Ilam Road, University Crossings – Post Construction Stage Road Safety Audit

Prepared for Christchurch City Council (Client)

By Beca Ltd (Beca)

23 August 2013

Figure 2-1 Note inconsistent tactile paving

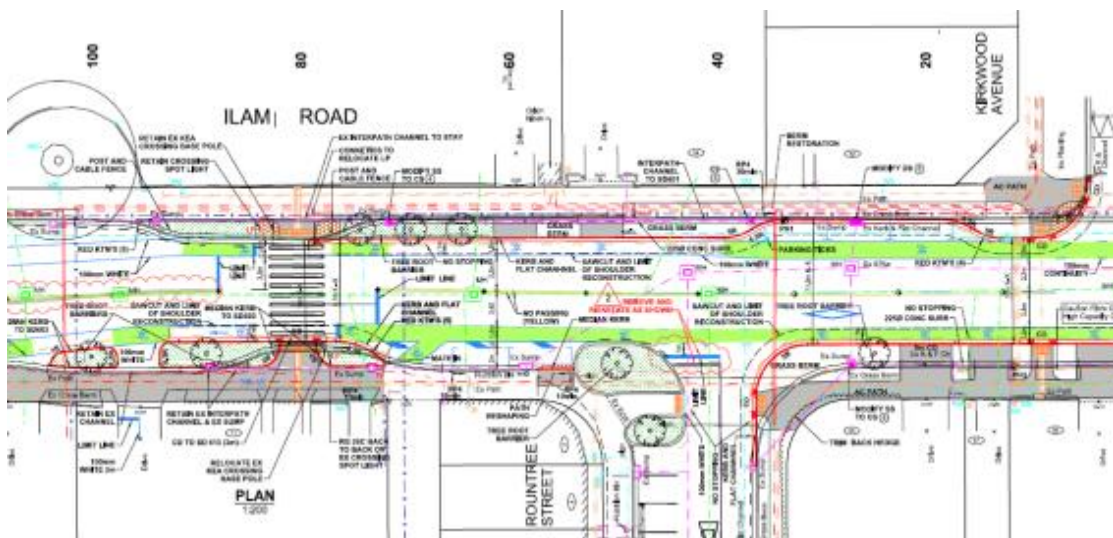
The tactile paving to the zebra crossing and crossing point adjacent to Kirkwood Avenue are inconsistent. There is no kerbside tactile paving on the eastern side of the zebra crossing and there is no directional paving to the eastern side of the informal crossing point adjacent to Kirkwood Avenue. This may make it more difficult for partially sighted users to determine the location of crossing points which could potentially result in conflict.

Figure 2-2 Zebra Crossing north of Rountree St. Note missing tactile paving

Figure 2-3 Crossing point adjacent to Kirkwood Avenue. Note no directional paving to crossing point

Consistently apply tactile paving.

Report Ref.	Rank.	Recommendation:	Designers Comments	Auditors Comments	Exception Reporting
2.1.1	Moderate	Tactile Paving in Vicinity of Rountree Street Consistently apply tactile paving.	Fig 2.3 Disagree. The layout of the tactile paving conforms to the philosophy of RTS14. Fig 2.2 Agree The missing warning tactile markers will be installed as identified in the issued Defects List	Accept conforms to RTS14. But ideally should be consistent with other crossings in the vicinity. Accept
